RECEIPT DATE: 9-25-17 **ONSITE SEWAGE DISPOSAL SYSTEM**

OSDS Plan
2039 Terrapin Creek Road
Terrapin Creek, Lot 15
Woodstock, MD 21163

The OSDS Plan for Terrapin Creek, Lot 15 has been reviewed with the following comments:

ON SITE SEWAGE DISPOSAL SYSTEM DESIGN PLAN

SEPTIC SYSTEM TRENCH DESIGN

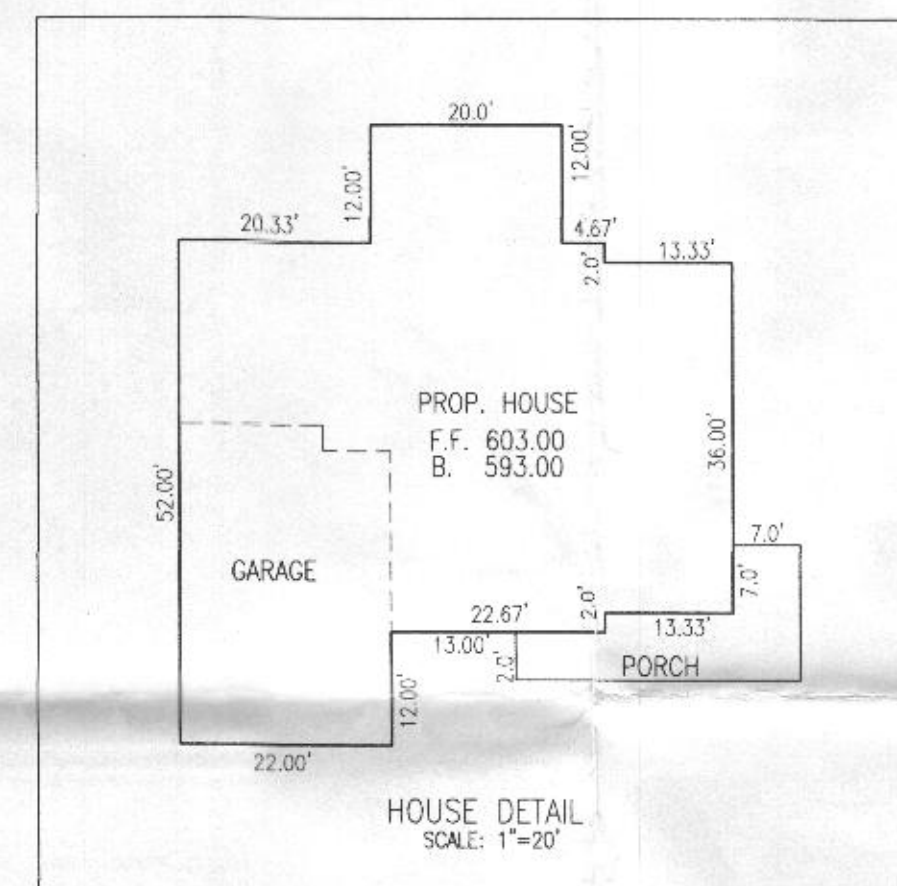
- 1.) The friction loss should be more like ^{2.75 using 1.5 GPM} 2.05 (per sand mound chart)
- 2.) The TDH would be more like ~~19.69~~ (use 20) ^{20.09} use .
- 3.) TDH of 20 intersects the pump curve at 35 GPM
- 4.) Pump should be a 1/3 HP, WE03.
- 5.) Pump runtime = 3 minutes.
- ✓ 6.) Change wording in calculation to 2nd replacement
- ✓ 7.) House detail elevations do not match Layout elevations on plan
- ✓ 8.) Move d-box inside SDA

ON SITE SEWAGE DISPOSAL SYSTEM DESIGN PLAN

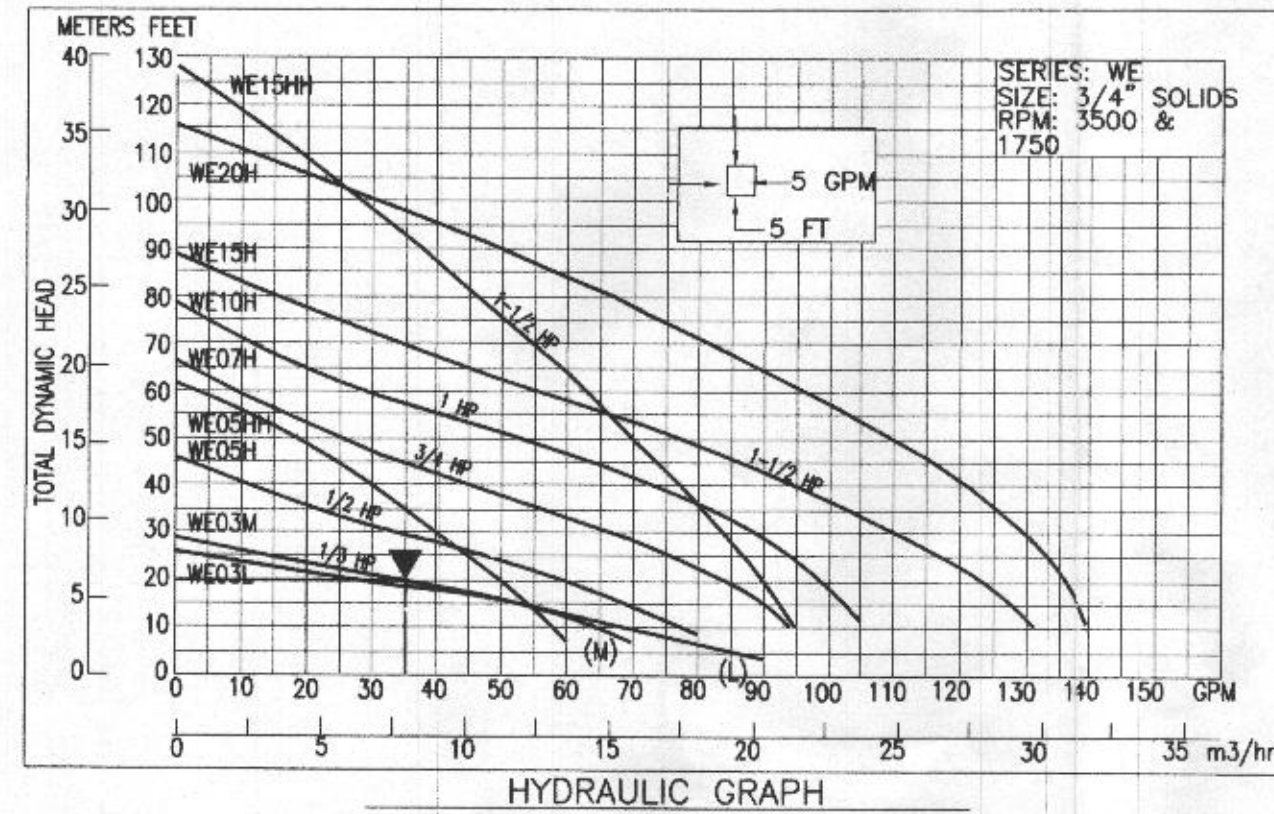
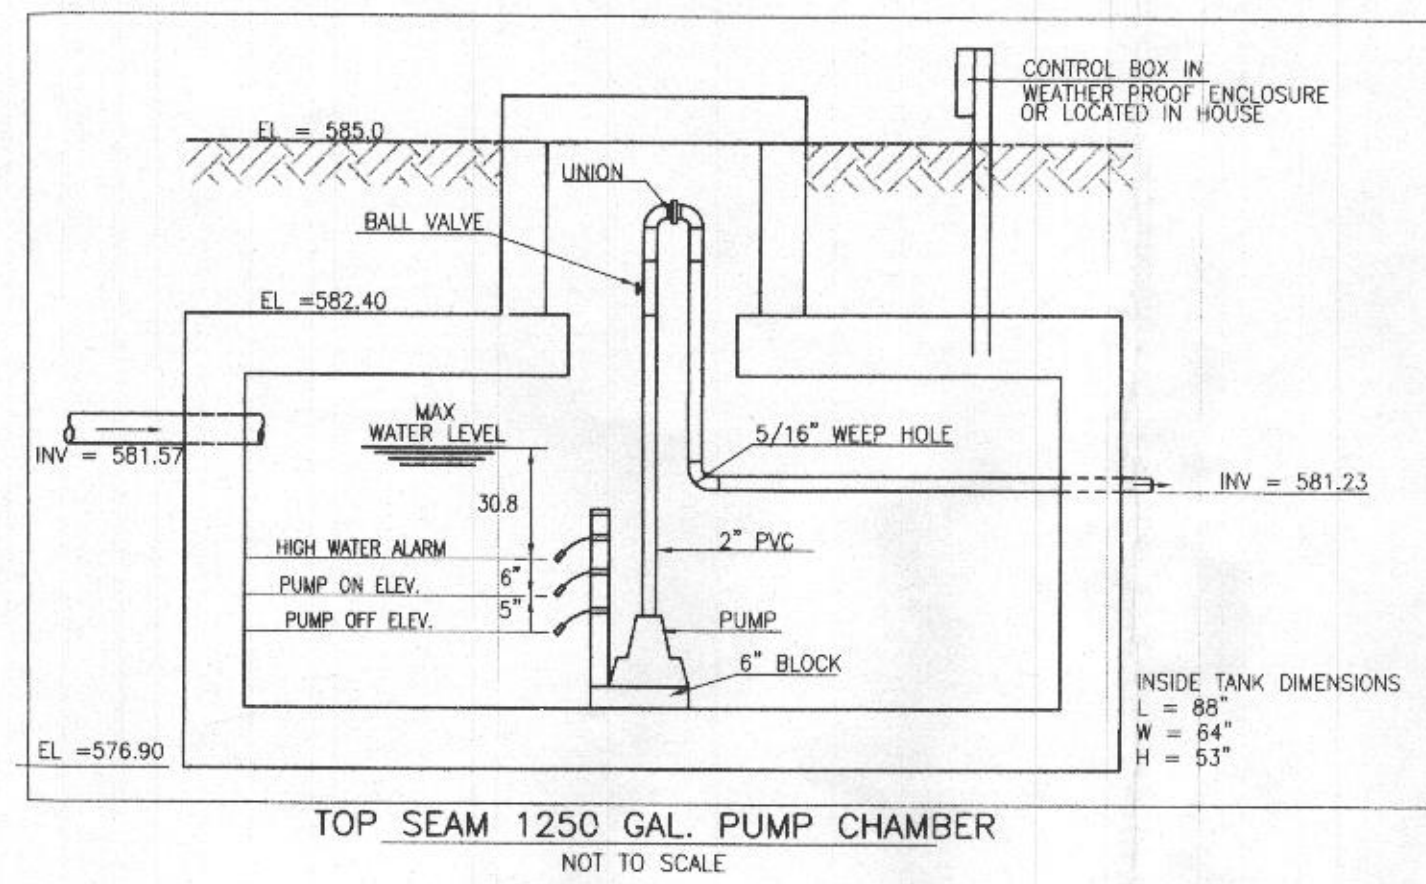
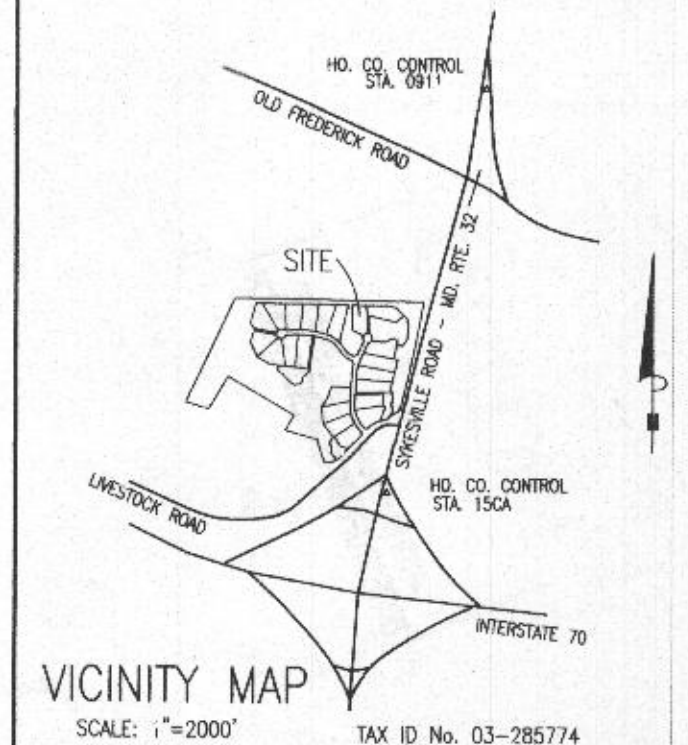
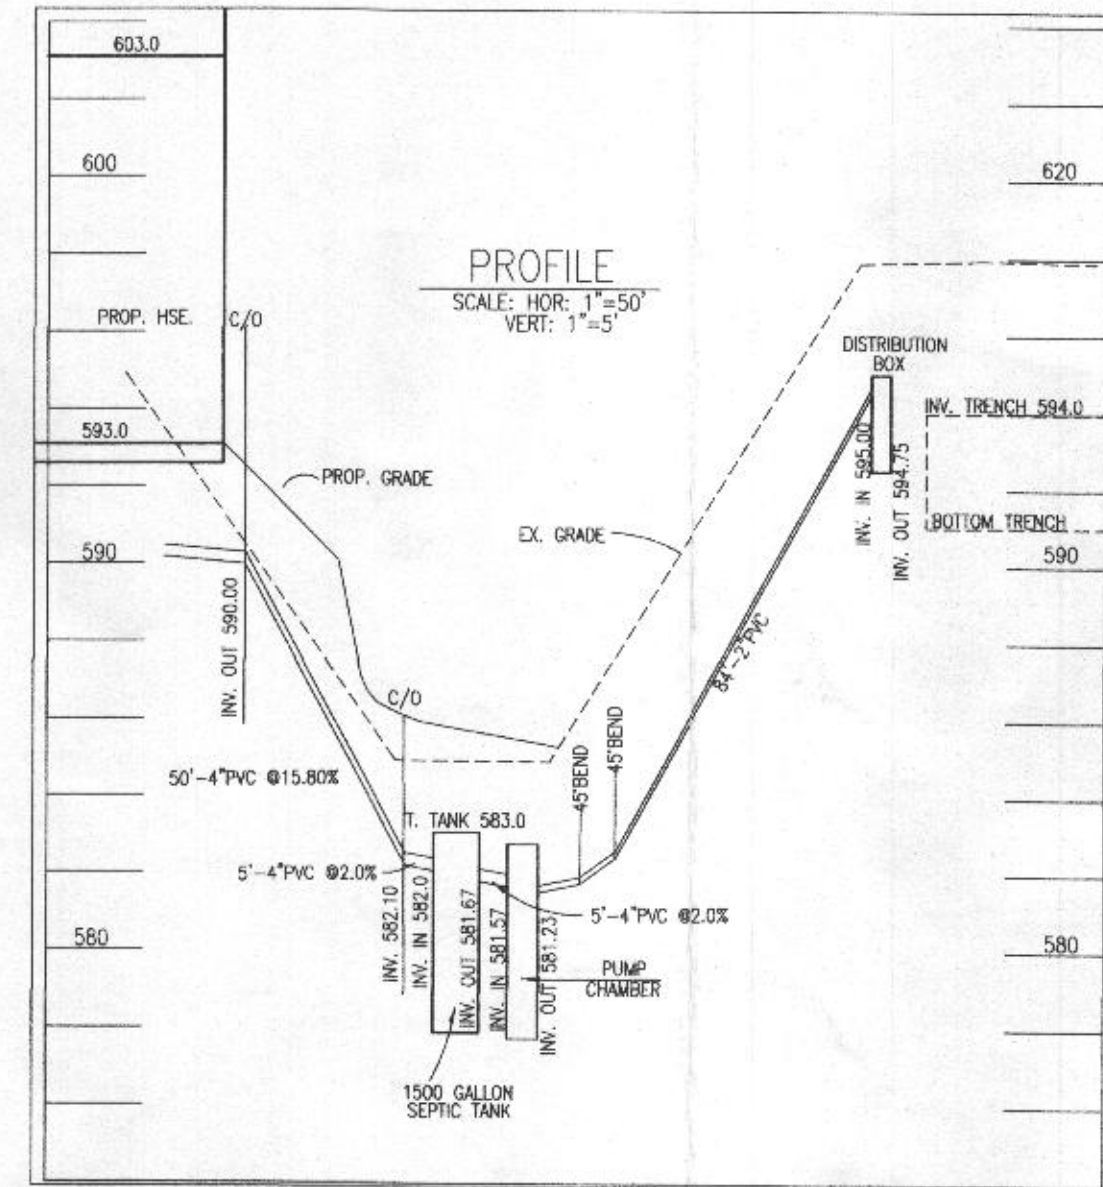
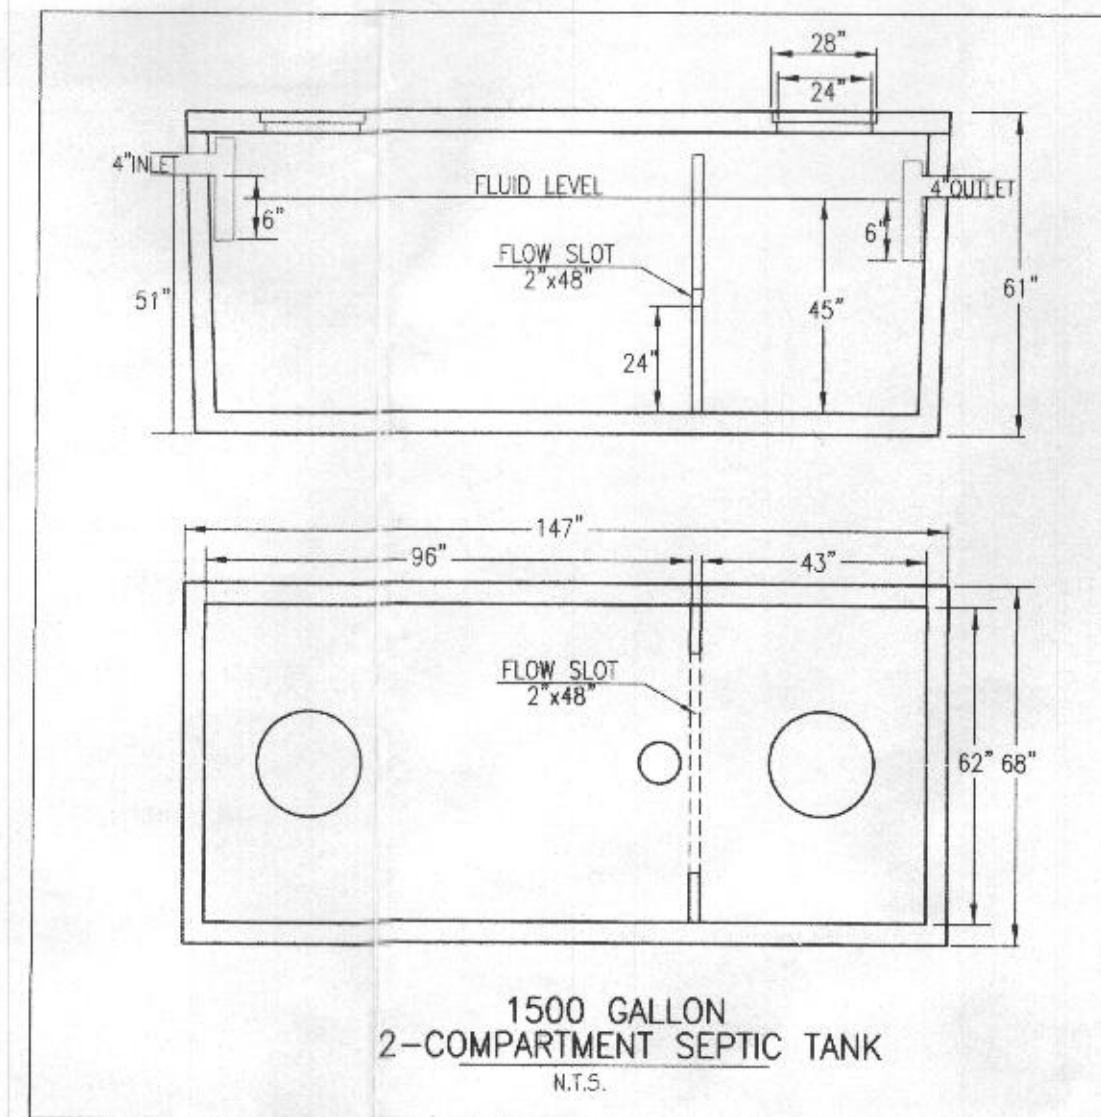
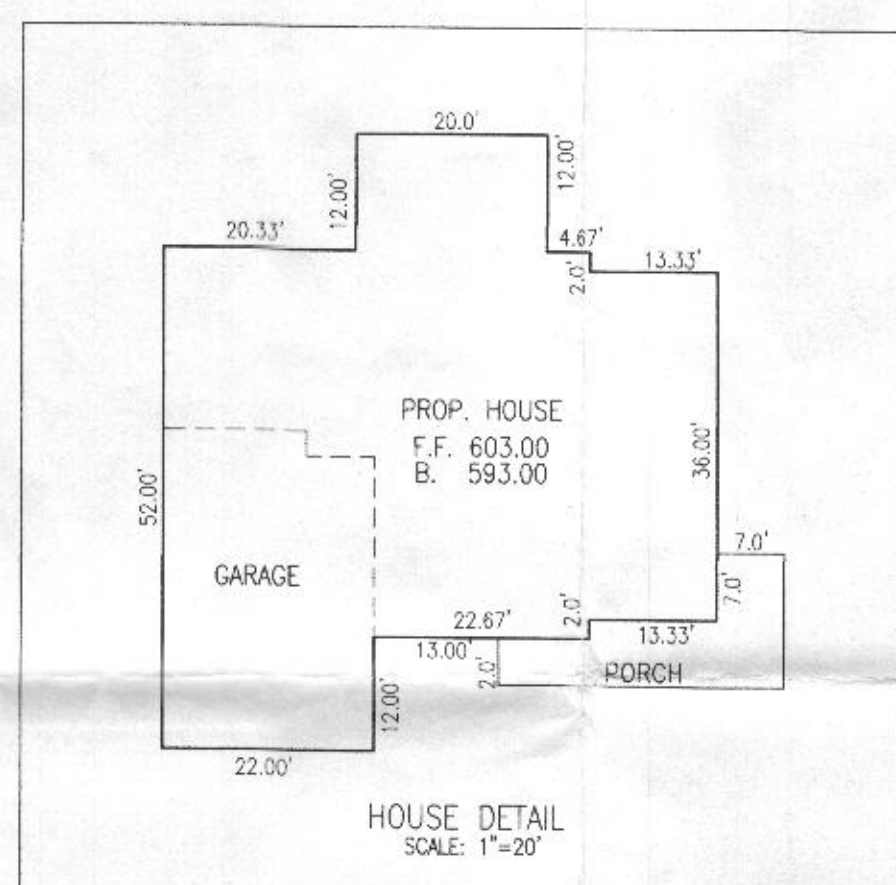
1. The friction loss should be more like 2.05 (per sand mound chart)

2. The TDH would be more like 19.69 (use 20).

3. TDH of 20 intersects the pump curve at 35 GPM.

4. Pump should be 1 / 3 HP, WE03.

5. Pump runtime = 3 minutes.

6. Change wording in calculation to 2nd replacement.

7. House detail elevations do not match layout elevations on plan.

8. *Move d-box inside SDA.*

Response 1: The computations were revised per the sand mound chart using a 3 minute run time (33.3 GPM). This provides a 1.85 factor for a friction loss of 2.39.

Response 2: The TDH is 20.03 (used 20).

Response 3: Pump curve intersection corrected to maximum 35 GPM.

Response 4: Pump corrected to 1 / 3 WE03M.

Response 5: Pump runtime revised to 3 minutes.

Response 6: Wording revised to 2nd replacement.

Response 7: House detail elevations corrected.

Response 8: d-box moved inside SDA.
